UNITED STATES PATENT AND TRADEMARK OFFICE

APPLICATION NO.	FILING DATE	FIRST NAMED INVENTOR	ATTORNEY DOCKET NO.	CONFIRMATION NO.
08/944,234	10/06/1997	VINCENT BRYAN	A8038	1173

# Office Action Summary

### DETAILED ACTION

Fig. 3

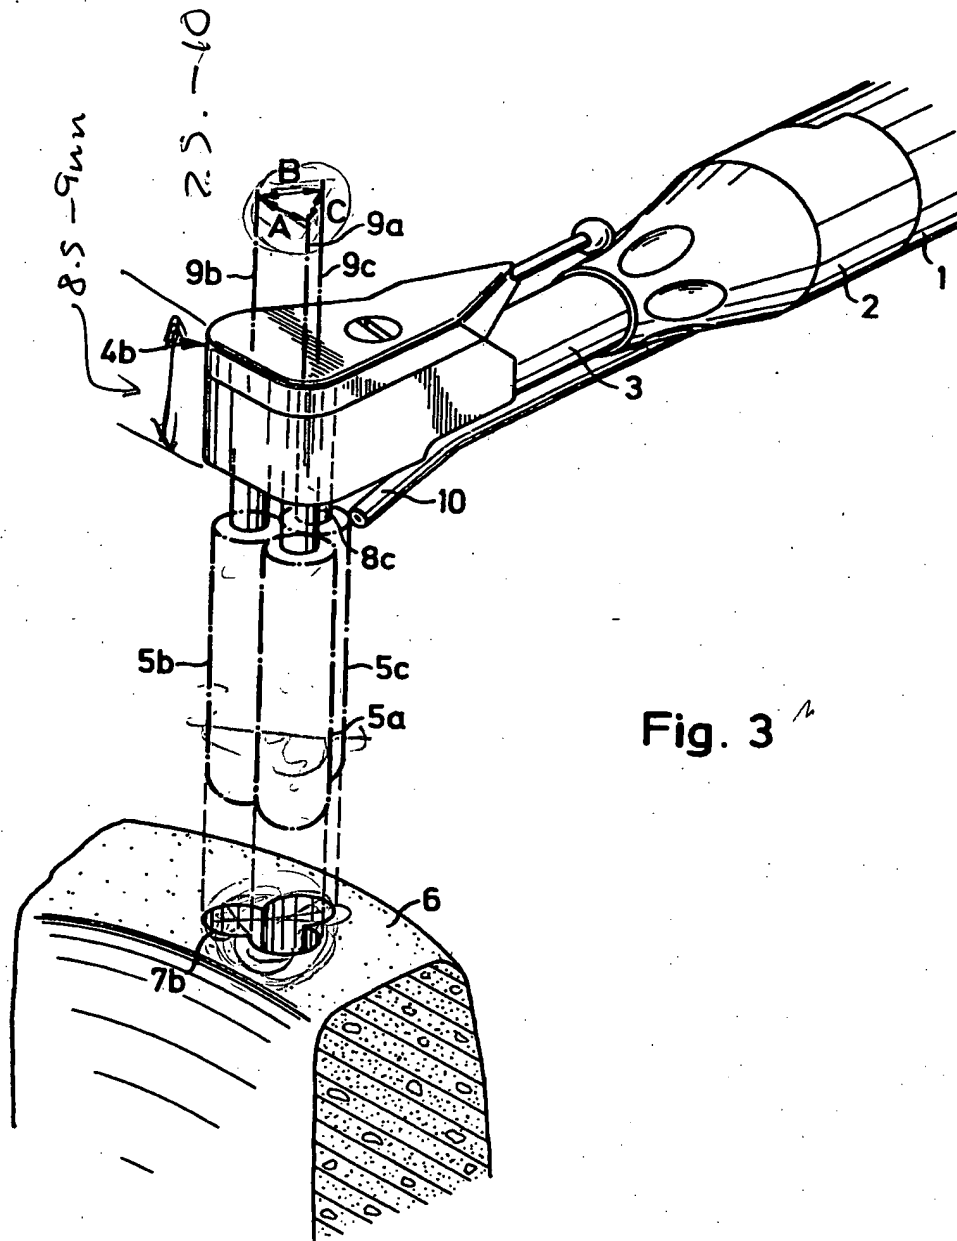
claims 37, "a smooth surface" is not supported in the original specification. Although each of figs 1-3 illustrates the surface 31 of the housing 20 being flat and smooth, but it is submitted that one ordinary skill in the art would appreciate that it is advantageous to provide a rough surface 31 to permit the housing to stay in a stable position as it contact to a vertebrae during milling the bone.
